August 19, 2016

Mr. John Oren, P.E.
Permits Chief
Waste Management Program
Pennsylvania Department of Environmental Protection
909 Elmerton Avenue
Harrisburg, PA 17110-8200

RE: Lancaster County Solid Waste Management Authority response to the
Department of Environmental Protection's Request for Additional Information related to the
Environmental Assessment of Frey Farm Landfill Vertical Expansion letter dated August 8, 2016.

**Figure
4**

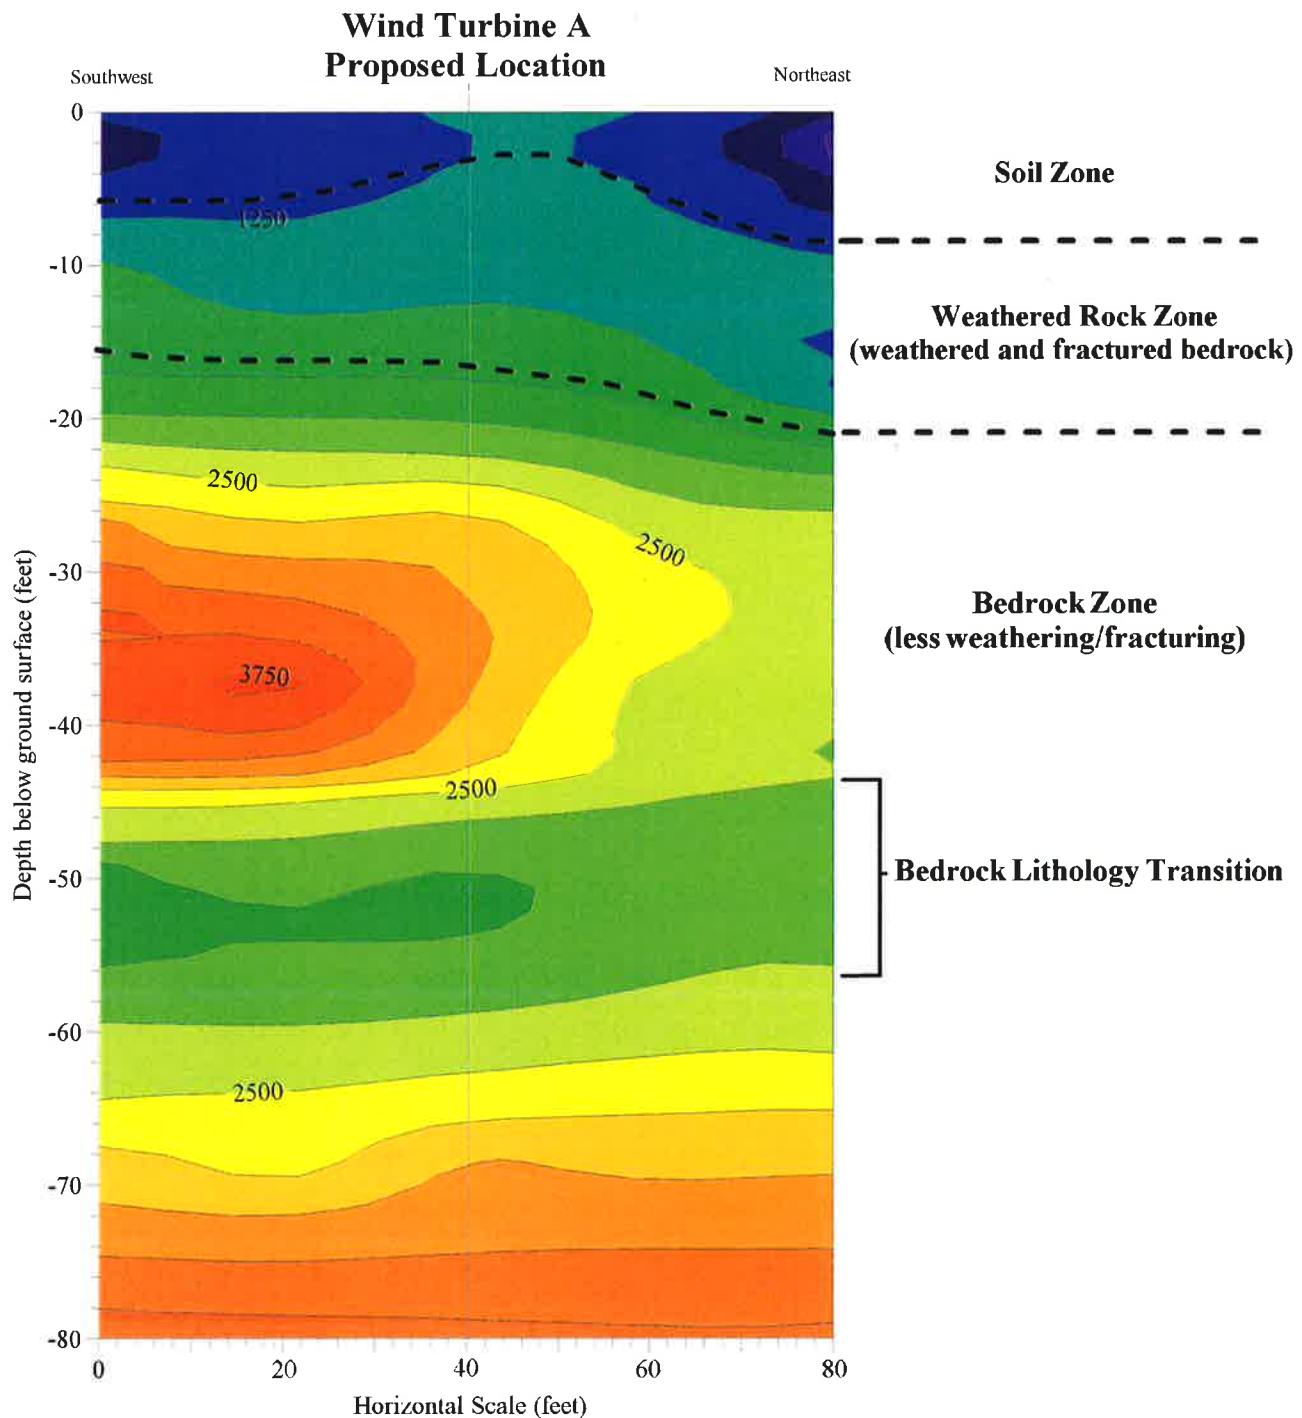
The ARM Geotechnical Engineering Report for the Proposed Frey Farm Landfill Wind Energy Project
dated April 2010 documenting shear wave velocity accompanies this letter as Attachment #2.

Two MASW profiles were collected at the site. The MASW profile collected over the site for Turbine A (see Appendix A - Figure 4) indicates subsurface shear wave velocities that vary from 450 feet per second (f/s) to 3,750 f/s. The soil zone is estimated to extend from the ground surface to depths of 3 to 6 feet below existing grade. Weathered rock occurs below the soil zone to depths of 16 to 18 feet below grade. Competent bedrock occurs below the weathered rock zone, as characterized by shear wave velocities ranging from approximately 2,000 to 3,750 f/s. The MASW profile collected over the site of Turbine B (Figure 5) indicates that the soil zone extends from the ground surface to depths of 22 to 28 feet below ground surface (bgs). Weathered rock occurs below the soil zone to depths of 34 to 37 feet bgs. Competent bedrock occurs below the weathered rock zone, and exhibits shear wave velocities ranging from approximately 2,000 to 3,600 f/s. Average shear wave velocity and shear modulus values for both wind turbines are shown in the table below.

DONEGAL SCHOOL DISTRICT
SCHOOL BUS STOPS ON LCSWMA TRUCK ROUTES

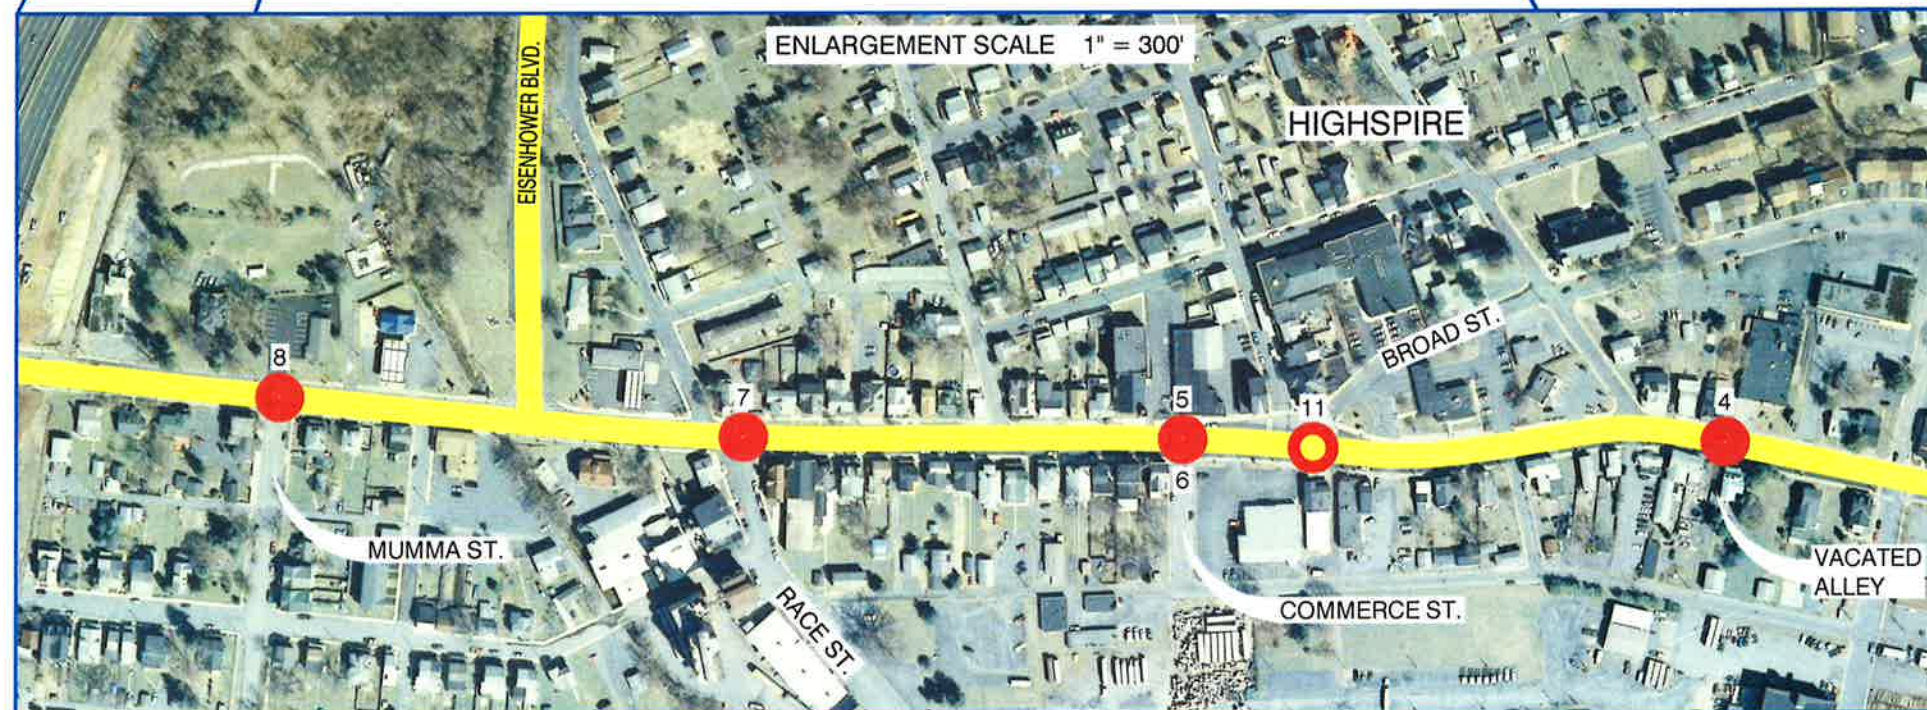
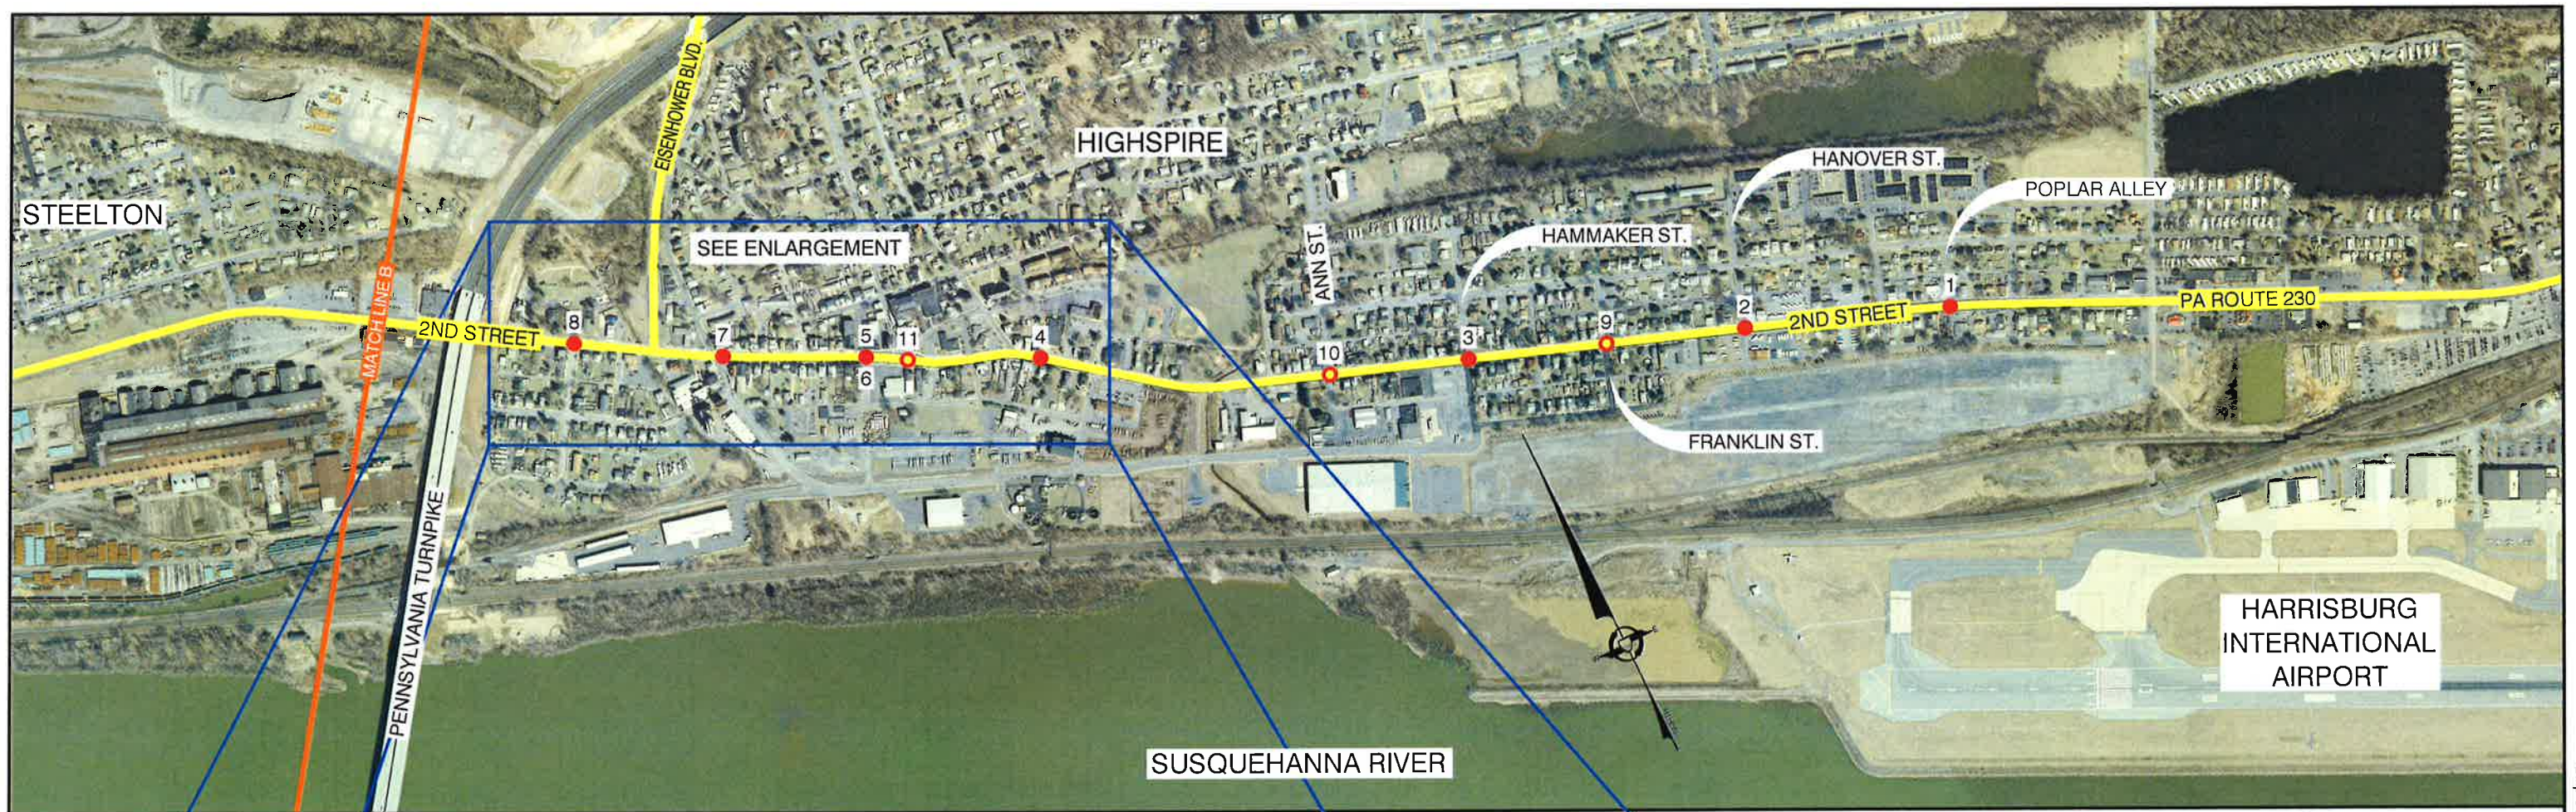
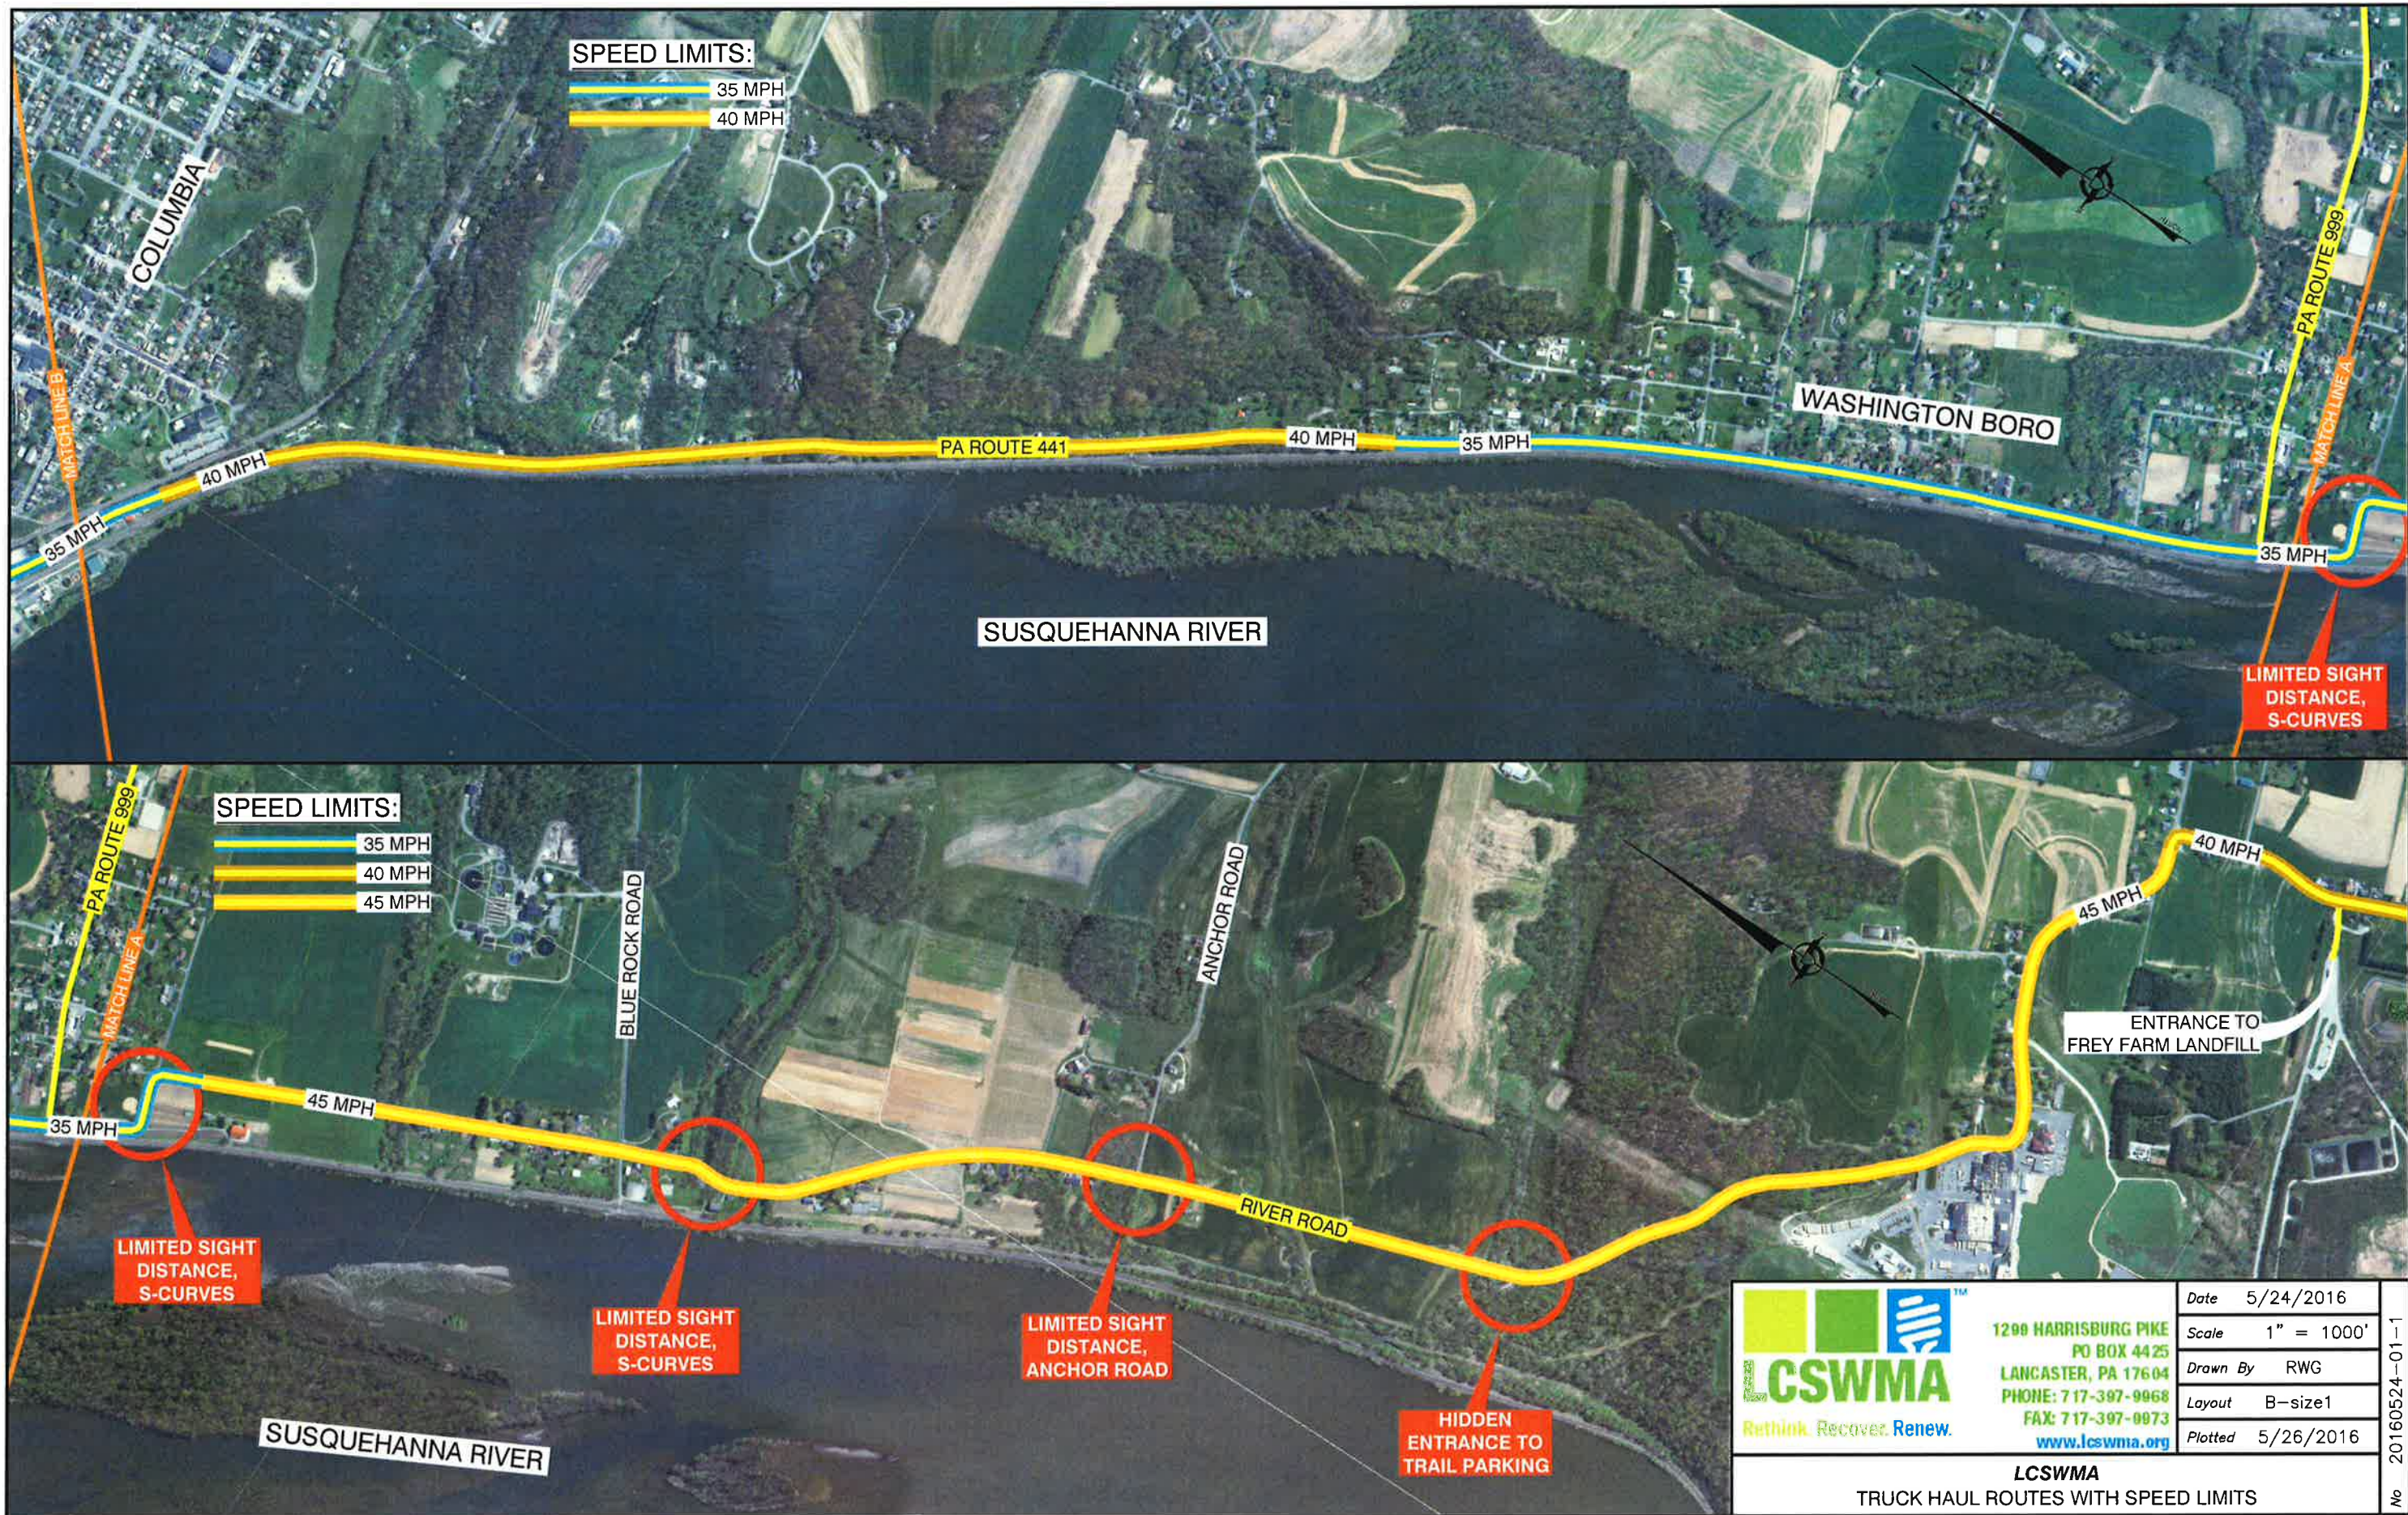
Response to Comment #4:

Waste haulers will be made aware of school bus stop locations on the remainder of the haul routes beyond what PADEP requested in the initial response letter by including additional maps within the Transportation Compliance Plan that shows the school bus stops located on the haul routes. An updated LCSWMA Hauler Packet accompanies this letter as Attachment #3.
